Access Compliance Report

Public Rights-of-Way

(Curb Ramps)

Intersection ID: 20986	Main Street: W_ARROWWOOD_RD	Cross Street: ARROWPOINT_BV	Location:	N
ADA ID: DBE1048BA071	Ramp Type: MedianPerp	Initial Pass/Fail: Fail	Overall Compliance: No	Severity Score: 12.5
Codes/Mitigation Info/Possible Solution		Field Measurements/Component Compliance

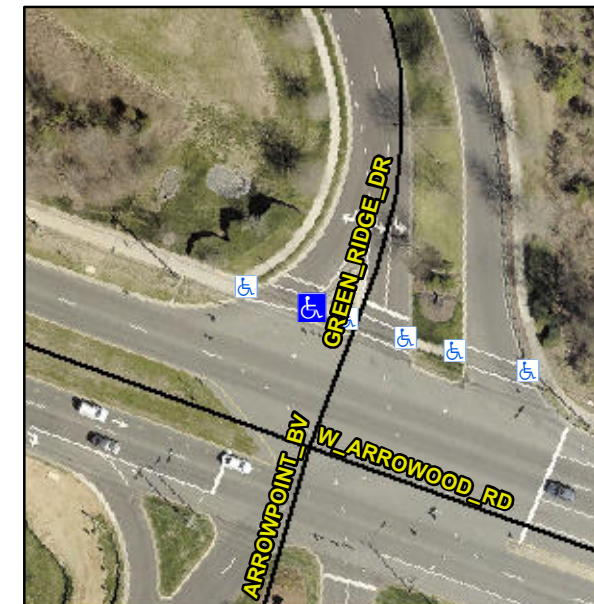
R304.2.2

Compliance	Description	Data	Compliance	Description	Data
N/A	Ramp Length (in)	53.0	No	Ramp Slope (%)	9.4
Yes	Ramp Width (in)	48.0	Yes	Ramp XSlope (%)	2.0
N/A	Flare Type LT	N/A	N/A	Flare Type RT	N/A
N/A	Flare Slope LT (%)	N/A	N/A	Flare Slope RT (%)	N/A
N/A	Flare Traversable LT?	N/A	N/A	Flare Traversable RT?	N/A
N/A	Landing Length (in)	N/A	N/A	DWS Provided?	N/A
N/A	Landing Width (in)	N/A	N/A	DWS Contrast?	N/A
N/A	Landing Slope (%)	N/A	N/A	DWS Length (in)	N/A
N/A	Landing X Slope (%)	N/A	N/A	DWS Full Width?	N/A
N/A	Landing Curb? (Y/N)	N/A	N/A	DWS Offset (in)	N/A
N/A	Shared Landing?	N/A			
N/A	Gutter Ponding?	N/A	N/A	Gutter Slope (%)	N/A
N/A	Gutter Lip Ht (in)	N/A	N/A	Gutter X Slope (%)	N/A
N/A	Painted X Walk1?	Yes	N/A	Painted X Walk2?	N/A
	X Walk 1 Direction	To NW		X Walk 2 Direction	N/A
N/A	X Walk 1 Width (in)	96.0	N/A	X Walk 2 Width (in)	N/A
	X Walk 1 Slope (%)	1.1		X Walk 2 Slope (%)	N/A
	X Walk 1 X Slope (%)	0.2		X Walk 2 X Slope (%)	N/A

Remove & Replace Entire Ramp.
